SEWAGE DISPOSAL SYSTEM

HOWARD COUNTY HEALTH DEPARTMENT
BUREAU OF ENVIRONMENTAL HEALTH
410-313-2640

P 514966
A REPAIR
ISSUE DATE 3/7/2001
APPROVAL DATE 3/20/01

SUBDIVISION _____ LOT NUMBER _____ ADDRESS 12496 Hall Shop Road

streambed
NOT TO SCALE

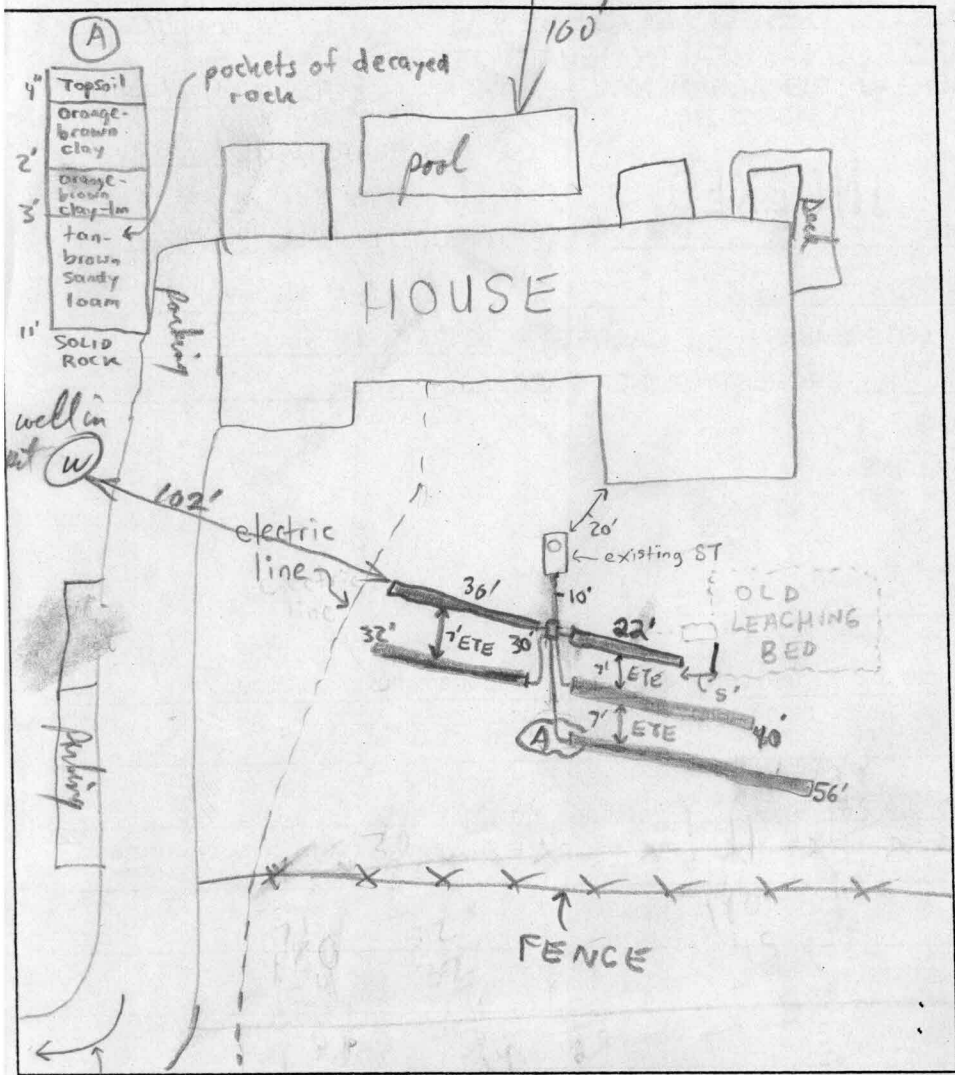
Set distribution box off of tank and run 4' Trenches angled on contour as discussed. try to keep trenches equal in length. -SRK

TO HALL SHOP ROAD
PRE-CONSTRUCTION INSPECTION: 2/12/01 - MET INSTALLER, DUG PERCHOLE IN LOCATION (A) SEE SOIL PROFILE, INSTALL SYSTEM AS DISCUSSED ON REVERSE (SRV)

INSPECTION COMMENTS: Hit all lead fill on one side, near electric line on other.
1st trench only 50' long (inlet @ 3', bottom @ 7') - open trench OK,
ok to continue work, RP 3/19/01

3/20/01 - BAFFLES IN EX. SEPTIC TANK OK, ex. terracotta 6" cleanout OK, OK TO COVER ALL WORK (SRV)
